# Abbott comment 53 IEEE 802.3aq LRM Draft 3.0

IEEE P802.3aq 10GBASE-LRM Task Force

January 2005 meeting, Phoenix

# 120m: 20um offset BW vs 20um PIE-D

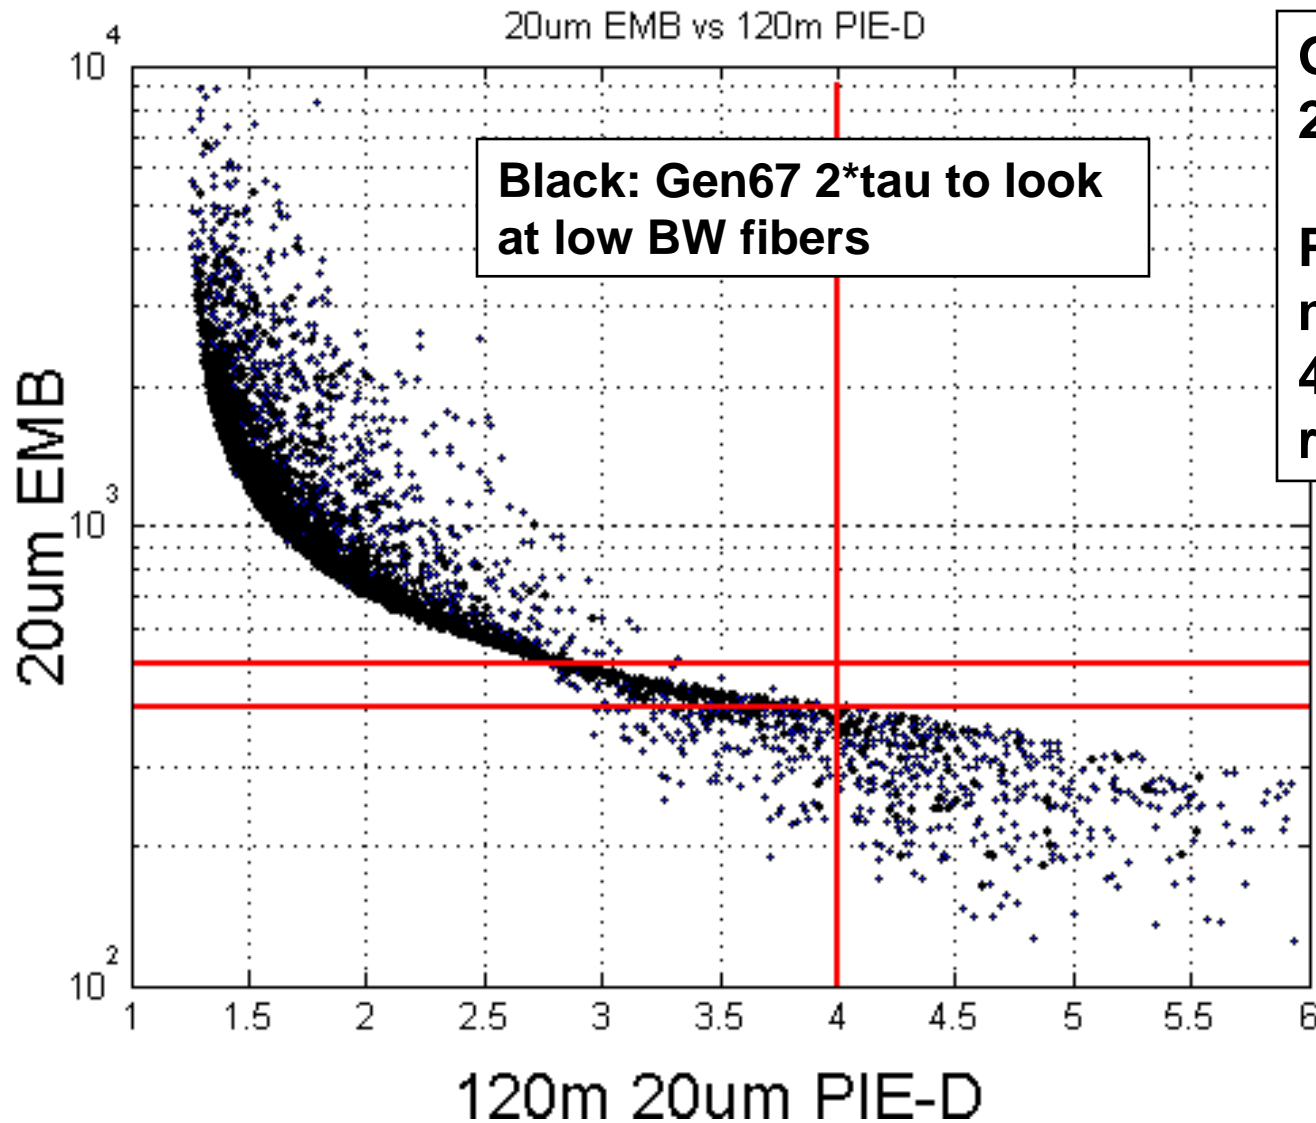
**Add informative footnote (e) to table 68-2 that 120m is achieved if laser BW of 400MHz.km is achieved with the launch condition.**

**Gen67 results at 20um.**

**PIE-D of 4dB means EMB of 400MHz.km is required for 120m**
